ALABAMA PECAN SUBDIVISION, PHASE 1

APPLICATION NUMBER 3 DATE March 15, 2018

REQUEST Subdivision

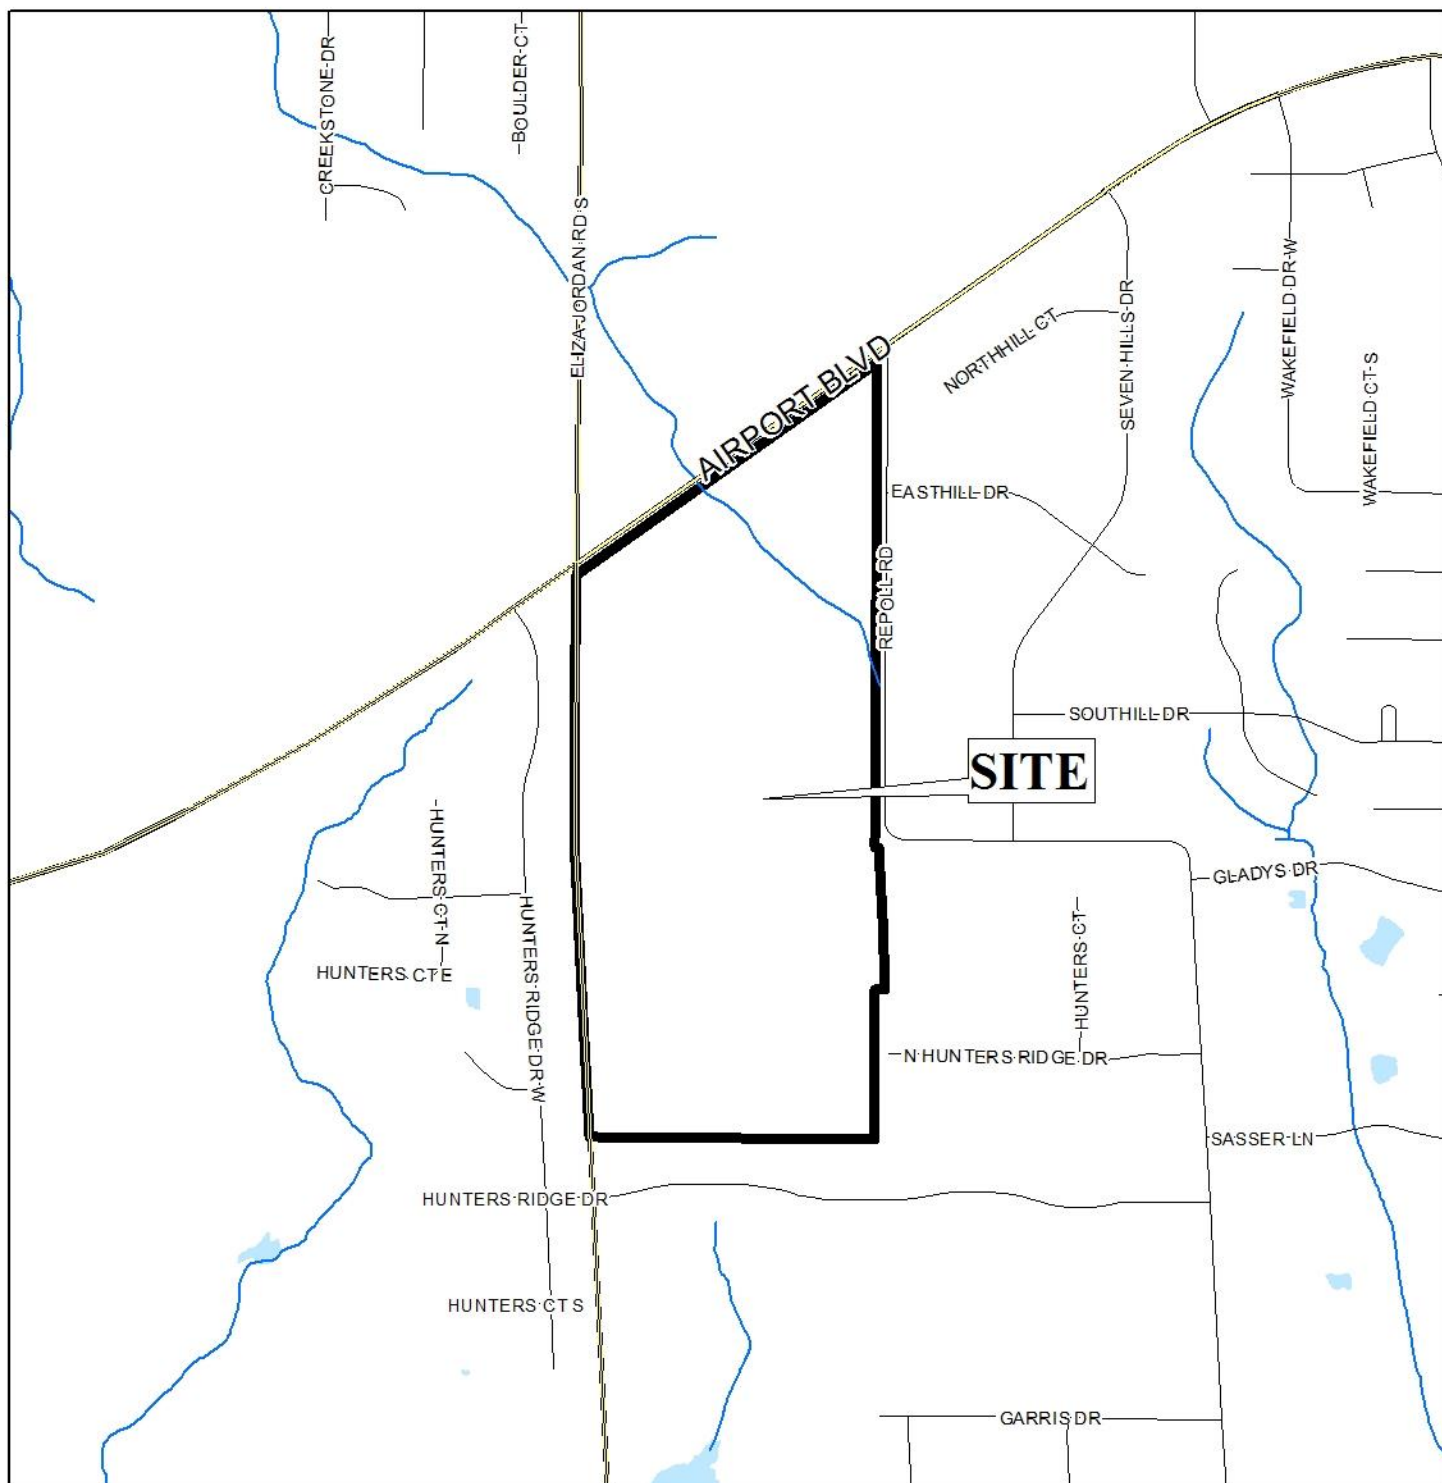
The plat illustrates the proposed 4 lot, 85.4 ± acre subdivision which is located on the Southwest corner of Repoll Road and Airport Boulevard, and is located within the Planning Jurisdiction. The applicant states that the subdivision is served by public water and sanitary sewer (South Alabama Utilities).

The site fronts Airport Boulevard and Repoll Road. Airport Boulevard is a proposed major street with a planned 100' right-of-way, as illustrated on the Major Street Plan. However, the plat indicates the right-of-way width of Airport Boulevard as 80'. Therefore dedication of any necessary right-of-way to provide 50' from centerline of Airport Boulevard will be required. The plat depicts Repoll Road as having a 60' right-of-way; therefore no dedication will be required.

The site is bounded along the west side by a proposed major street, a new connection linking Eliza Jordan Road to Johnson Road West. The right-of-way is proposed to be 100 feet, thus the plat should be revised to reflect dedication of the right-of-way.

Due to the impact the proposed major street may have on the proposed subdivision, it is recommended that the request be heldover until the April 19th meeting so that the preliminary plat can be revised.

Based on the preceding, the application is recommended for Holdover to April 19th with a revised plat reflecting the proposed Eliza Jordan Road major street extension to be submitted by Wednesday, March 28th.
